Moreno Duplex  
N 14th st.  
Erwin, NC

Job Number:  
1348-22

**Joe Moreno**  
**Mingo A (Left Side of Duplex ONLY)**  
**1st FLOOR I-JOIST PLACEMENT PLAN**

FOUNDATION PLAN  
SCALE: 1/4" = 1'-0"

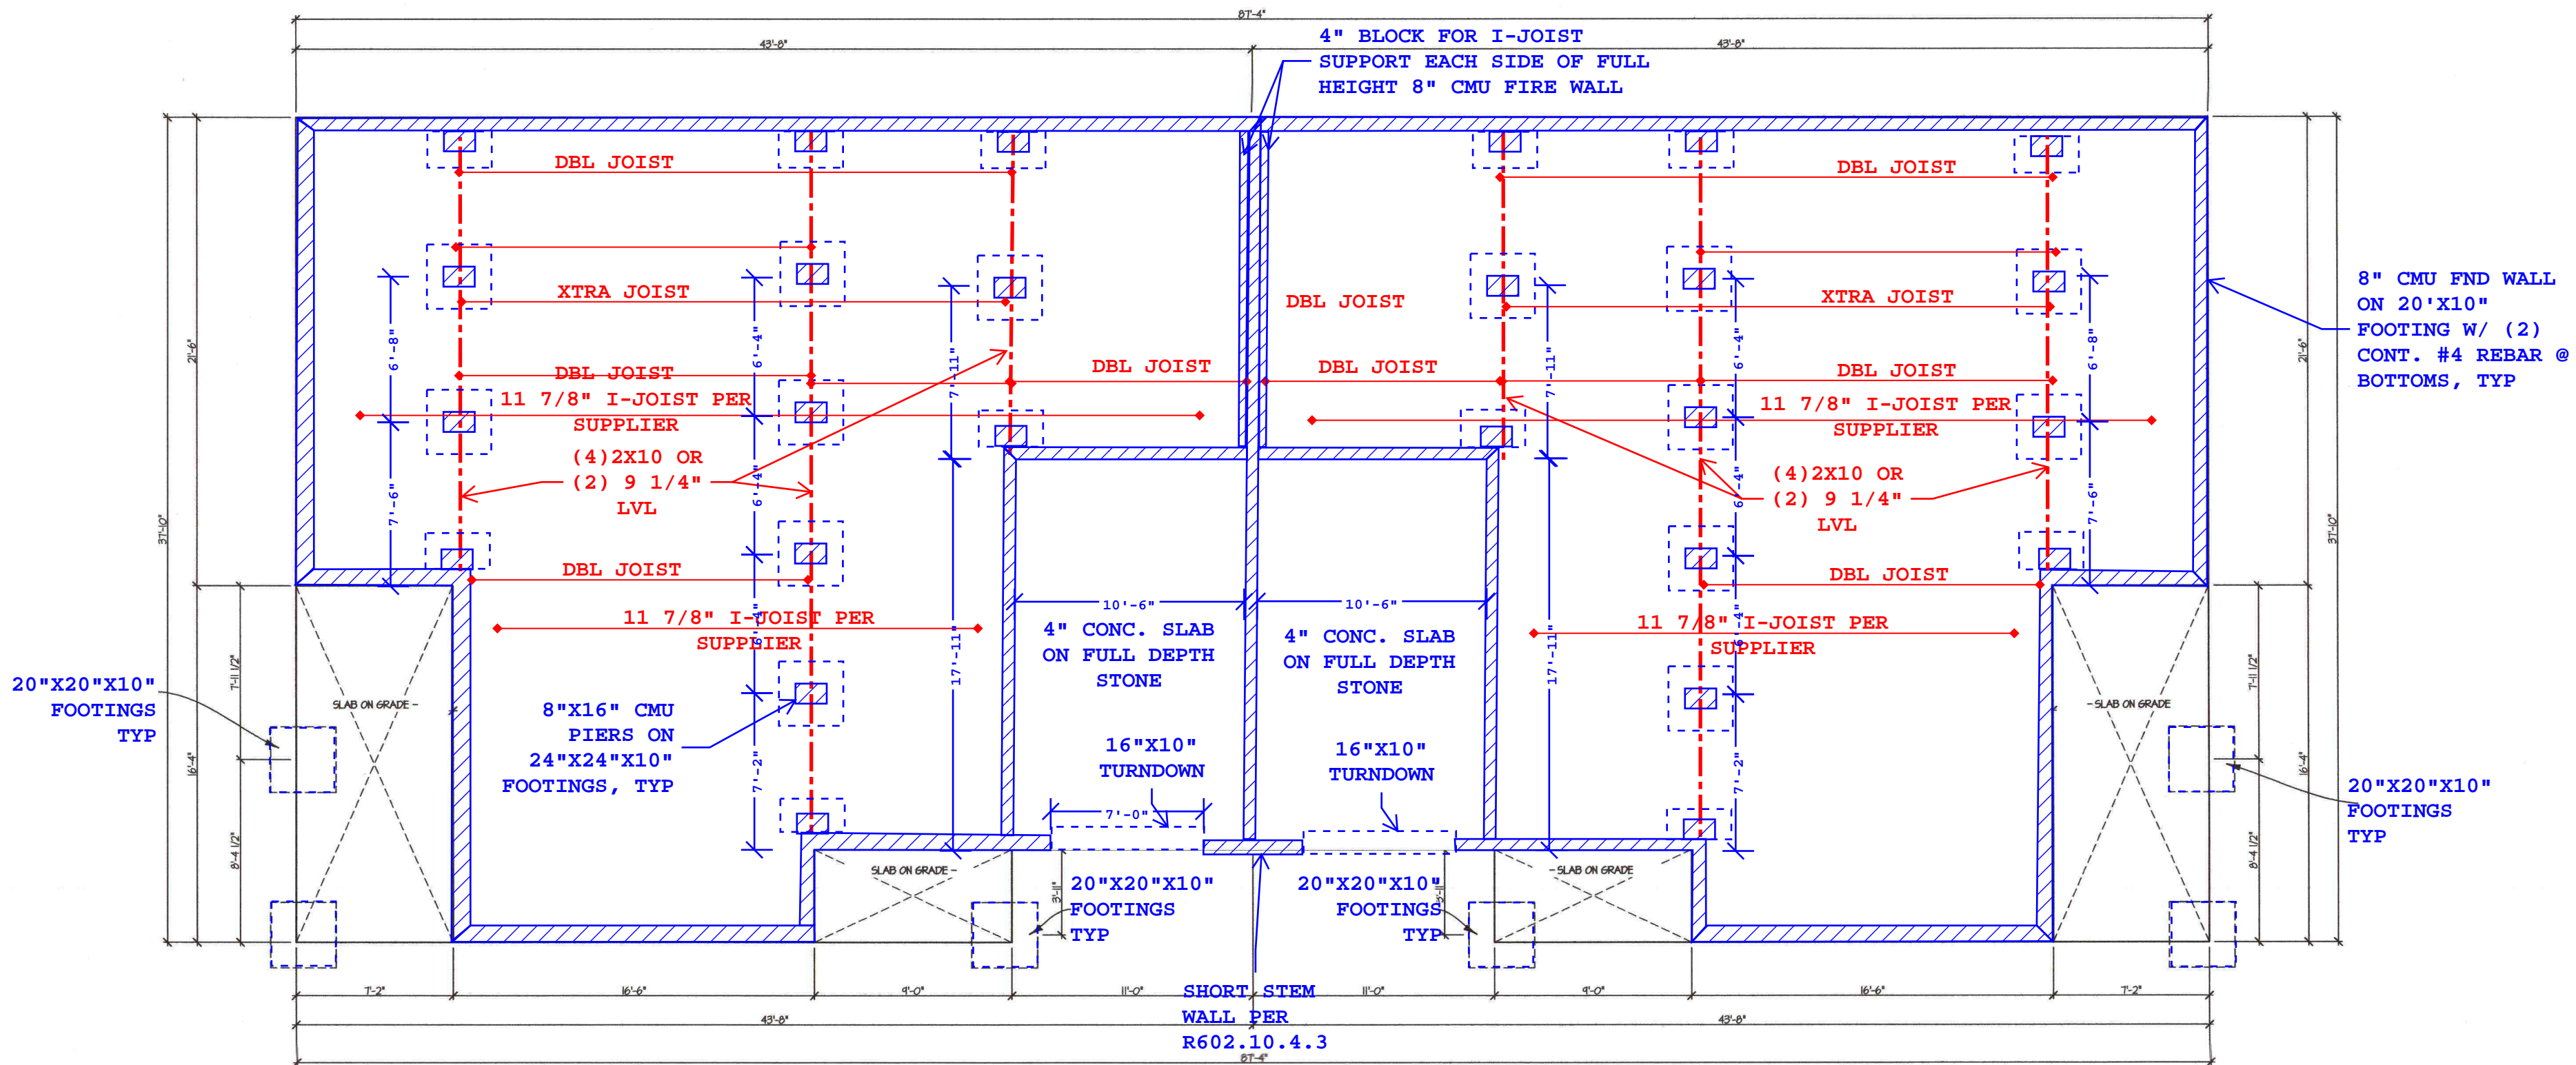
**I-JOIST LAYOUT  
REVIEWED AND  
APPROVED BY  
EOR. S1  
REFLECTS  
I-JOIST LAYOUT**

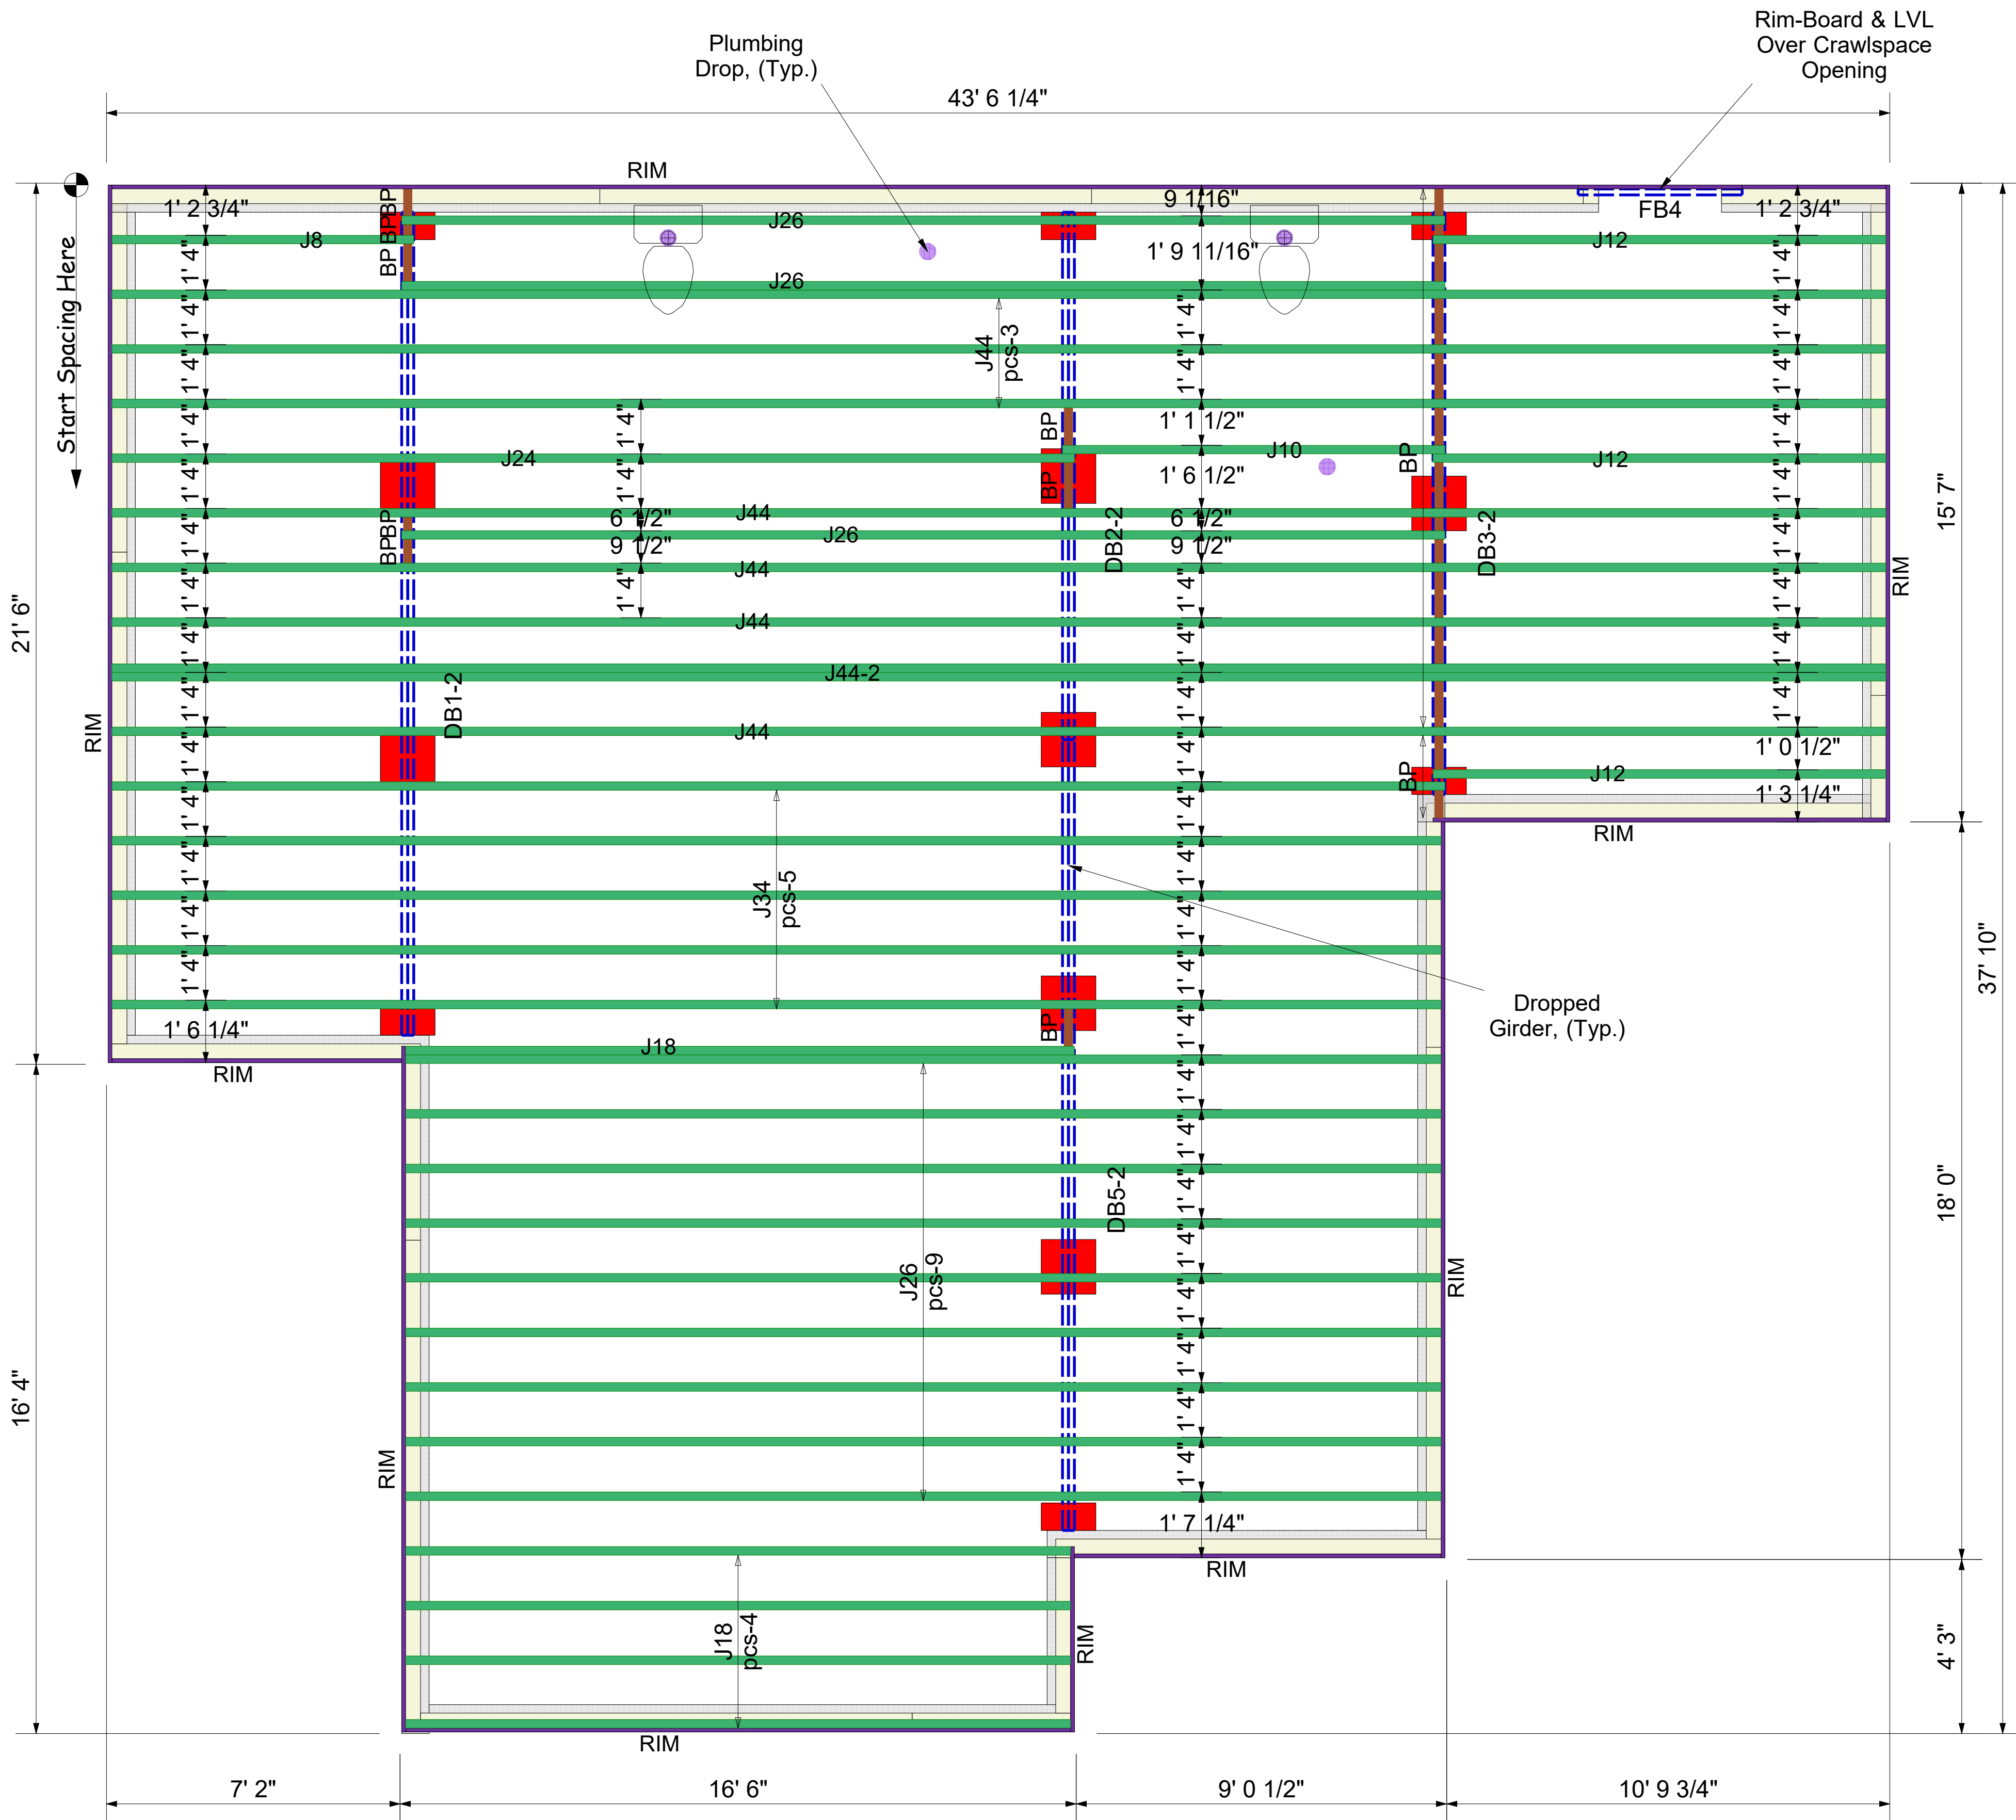
BLOCK SOLID UNDER ALL POST /POINT LOADS FROM ABOVE - TYPICAL AT ALL LOCATIONS

**FLOOR PLAN**  
SCALE: 1/4" = 1'-0"

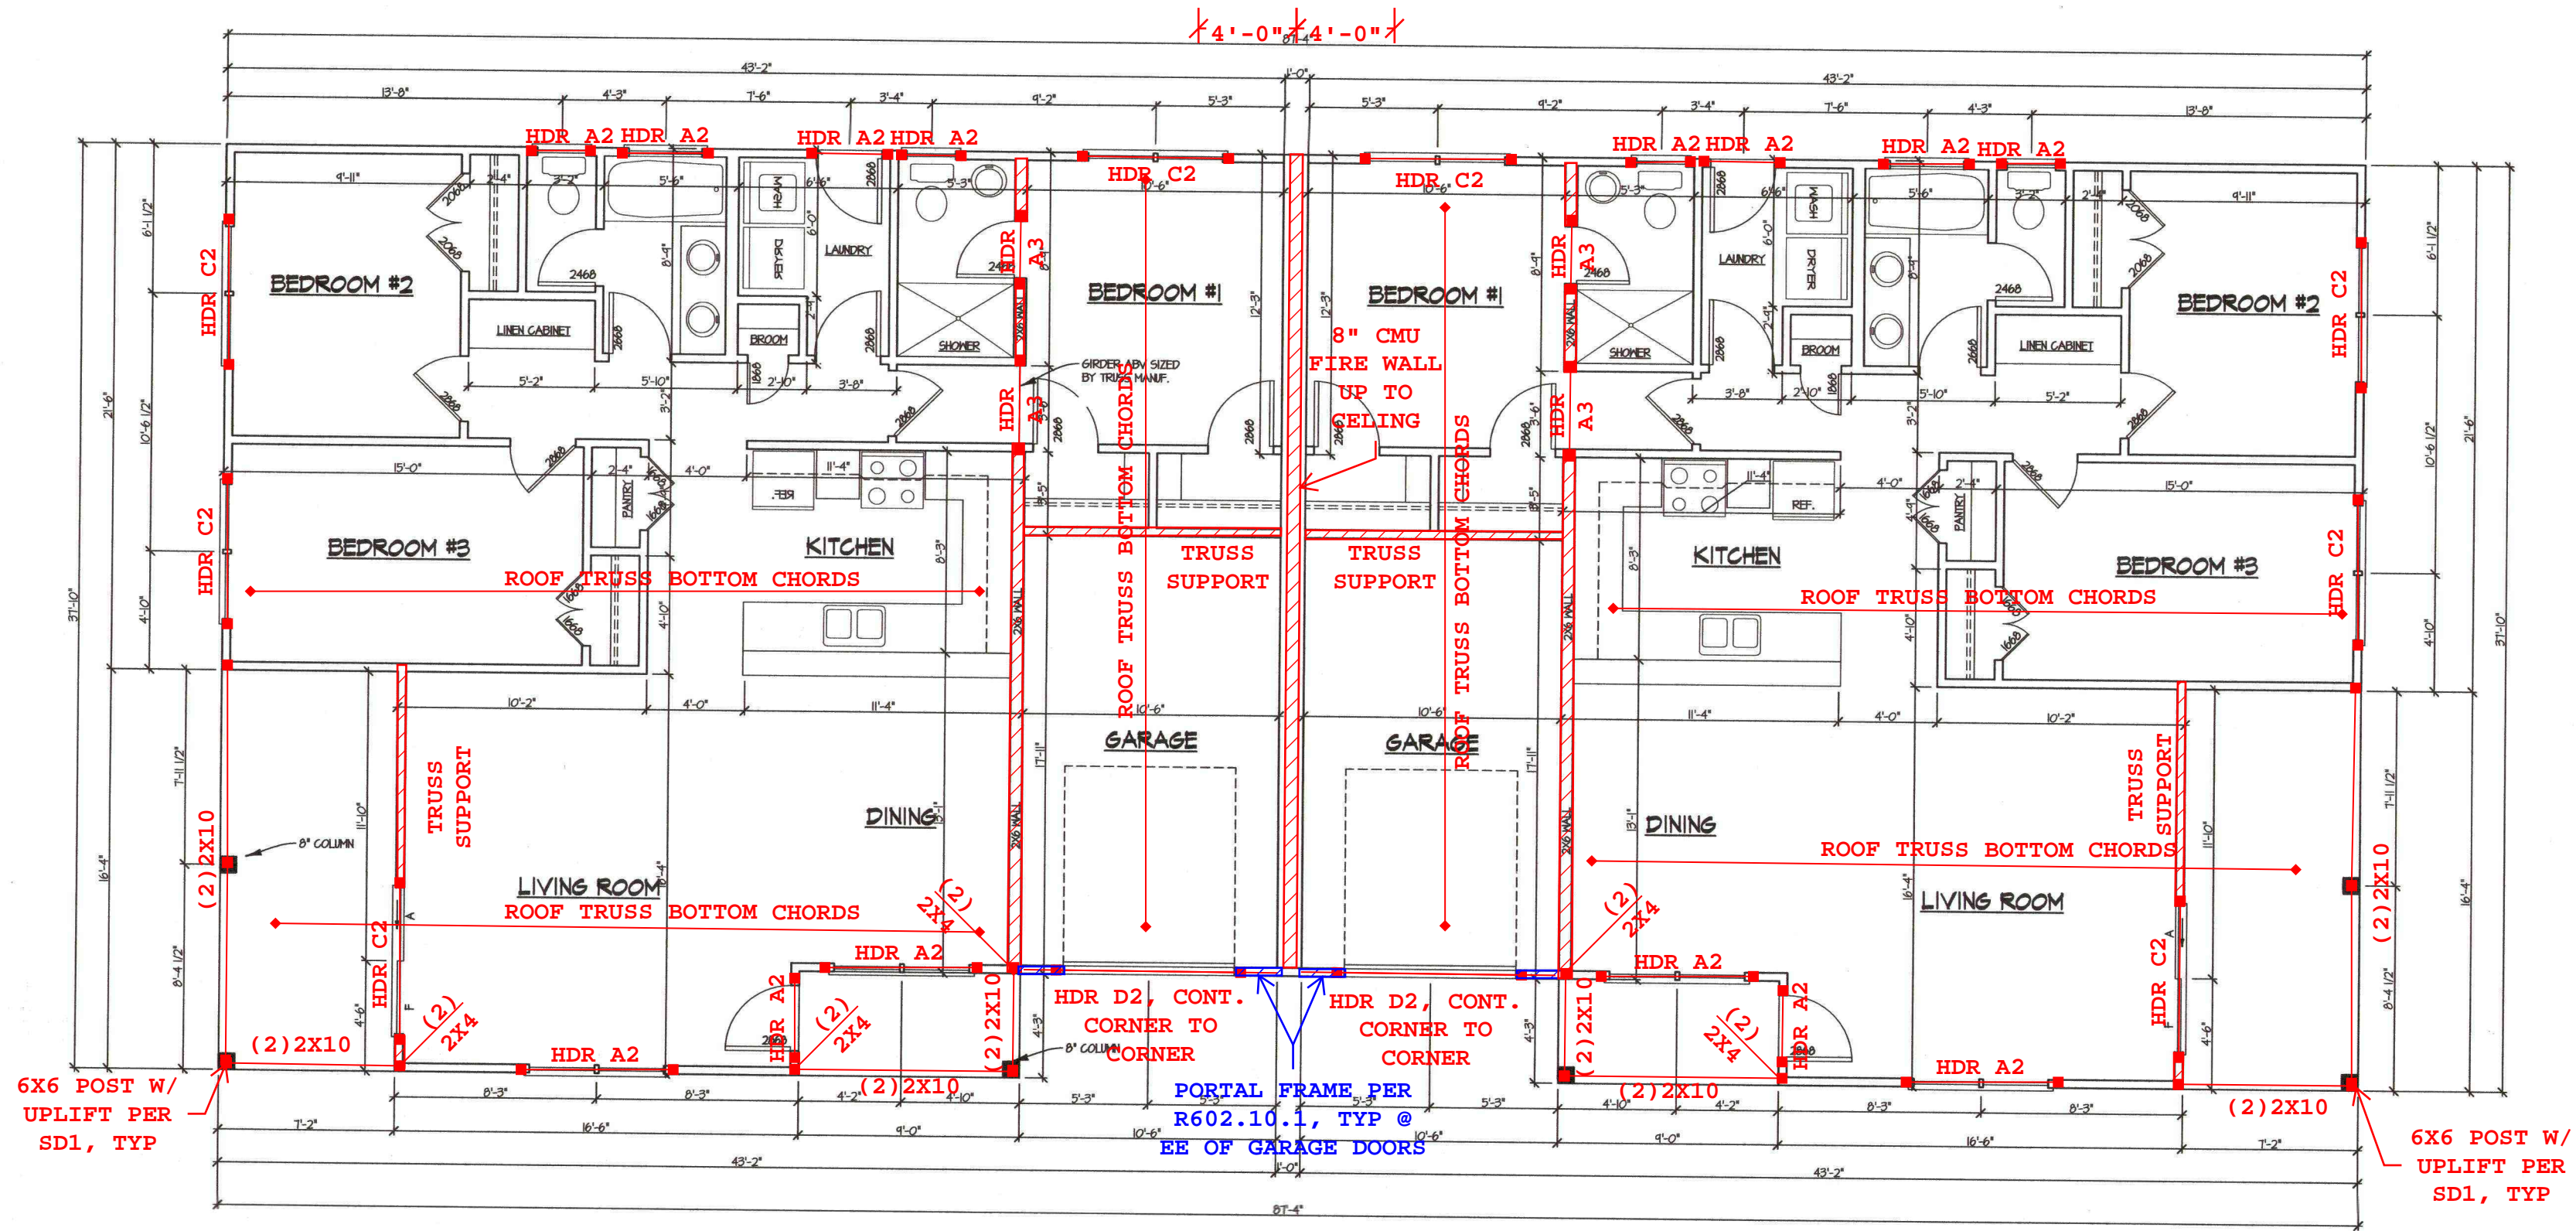
INTERIOR FOOTINGS MAY BE NEEDED DEPENDING ON TRUSS DRAWINGS TO BE PROVIDED BY TRUSS MANUFACTURE. BUILDER IS RESPONSIBLE FOR COORDINATING PRIOR TO CONSTRUCTION.

PORTAL FRAME PER  
R602.10.1, TYP @  
EE OF GARAGE DOORS
